# **3 Volt Intel StrataFlash<sup>®</sup> Memory**

## **28F128J3A, 28F640J3A, 28F320J3A**

### **Specification Update**

Order Number: 298130-014

Figure 1. AC Waveform for Standard Word/Byte Read Operations

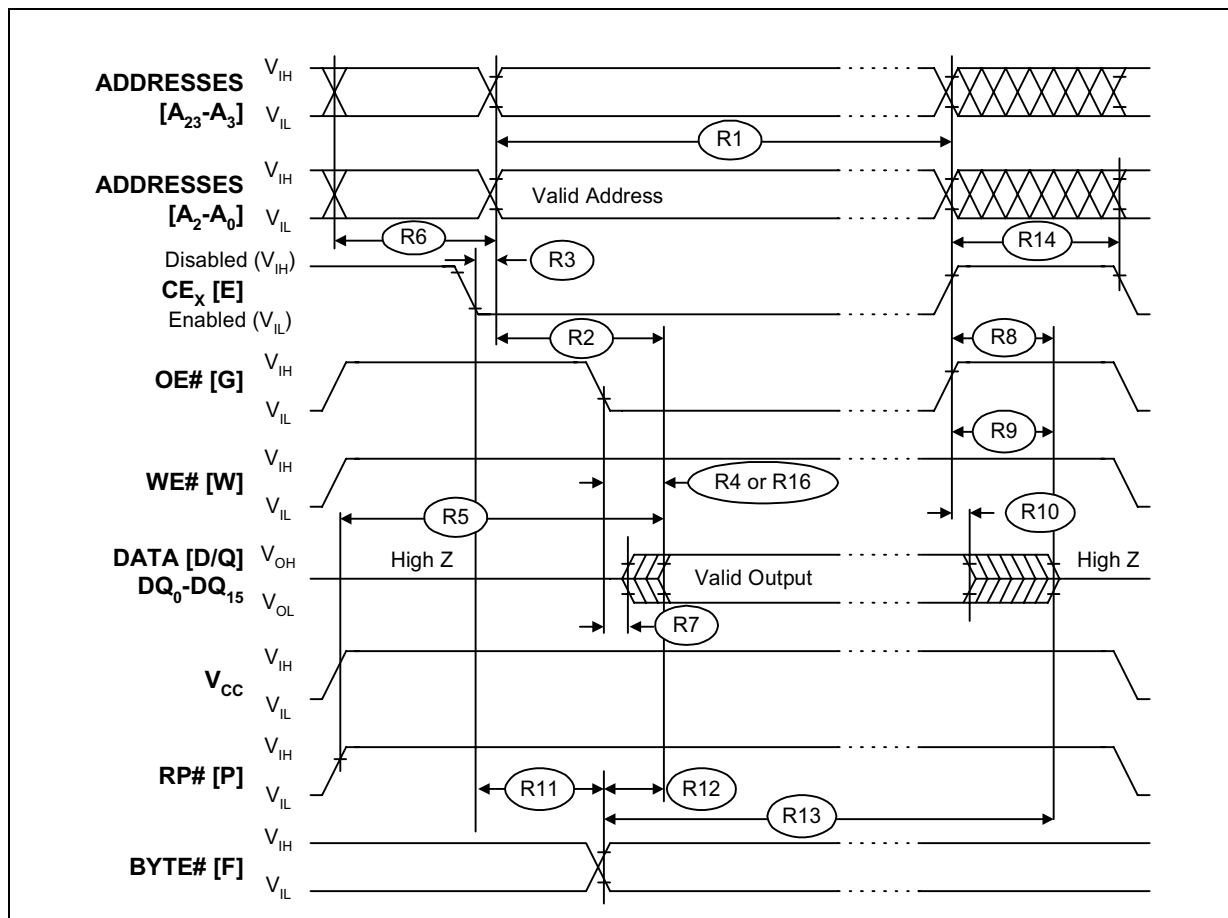
Problem: Devices need the parameter  $t_{ELQX} = 150$  ns minimum. CE low to output in low Z ( $t_{ELQX}$ ) is designated as R6 in Figure 1, in this Specification Update revision.

Problem: Devices need the parameter  $t_{ELAV} = 500$  ns maximum. Chip Enable to Address Valid ( $t_{ELAV}$ ) is designated as R3 in Figure 1, in this Specification Update revision.
